Subject: Comments Concerning Proposed/ Draft USEPA NPDES Permit
(CA 0005241), Dry Creek Rancheria Band of Pomo Indians (River Rock
Casino Site)

To: Ralph Sceales, Alexander Valley Association
From: Tom Grovhoug, Larry Walker Associates
Date: August 9, 2006
Subject: Preliminary analysis of the proposed NPDES permit for the discharge of treated wastewater from the Dry Creek Rancheria to local surface waters

Figure 4-2
Local Hydrology

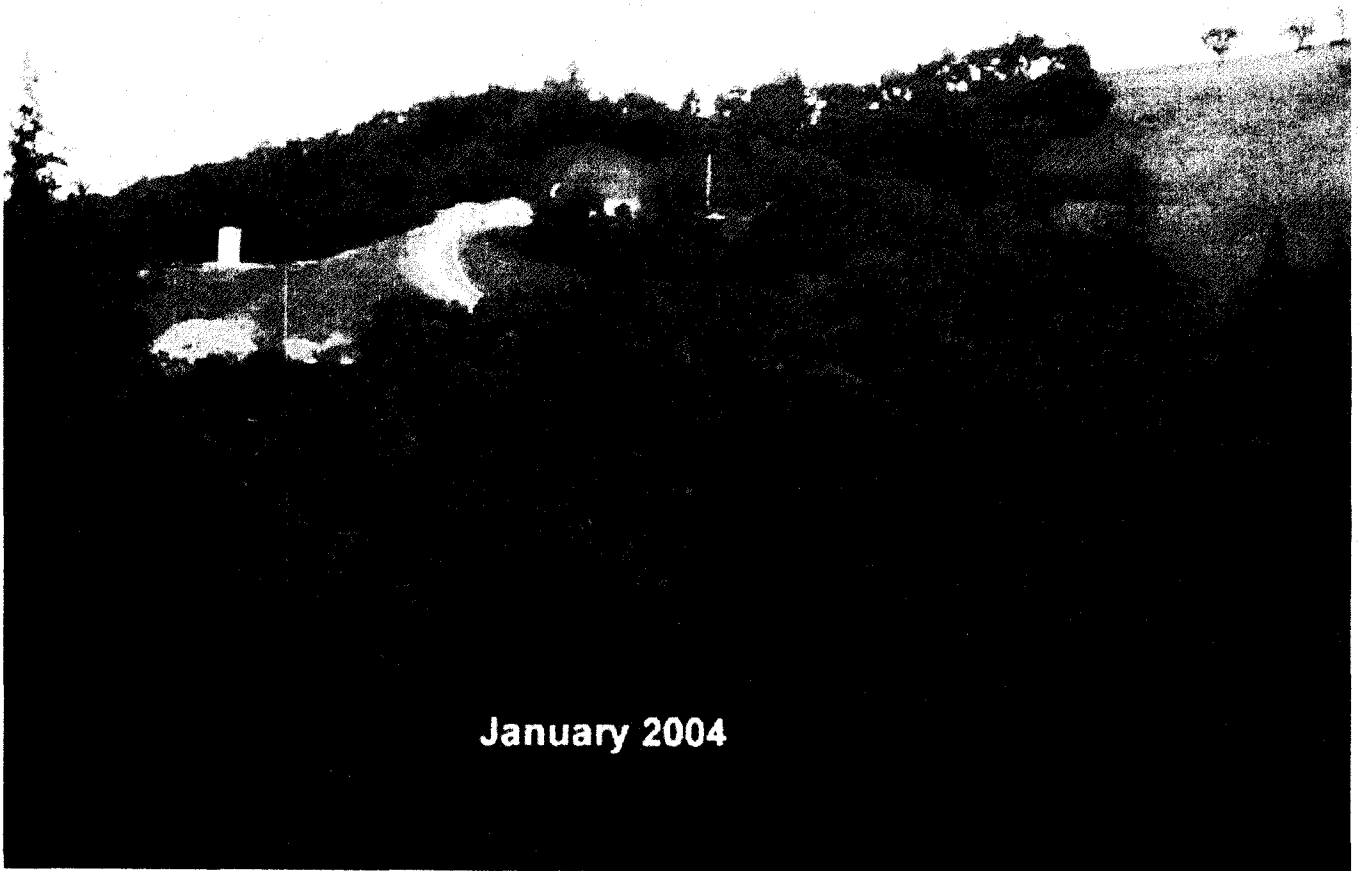
Notwithstanding that the Permit expressly and quite properly prohibits any sheet flows from either Stream P1 or Stream A1 to surrounding property, the Tribe itself has acknowledged in earlier filings with the federal government that sheet flow is the usual and invariable outcome of waters transported through Stream A1. We call EPA's attention to the "Dry Creek Rancheria Fee to Trust Project Final Environmental Assessment" dated August 2005, which was prepared by the Tribe's environmental consultants, ESA, for the US Department of Interior's Bureau of Indian Affairs. In that FEIS, a "Wetland Delineation Report," included at Appendix C, discusses at some length the characteristics of Stream A1. Of particular interest here is Figure 4-2, which depicts very clearly the sheet flow condition that is an inherent characteristic of this watercourse. Figure 4-2 candidly demonstrates that waters reaching its terminus will be discharged by sheet flow to the surrounding vineyards located on private property south and east of Highway 128. (A copy of Figure 4-2 is attached.)
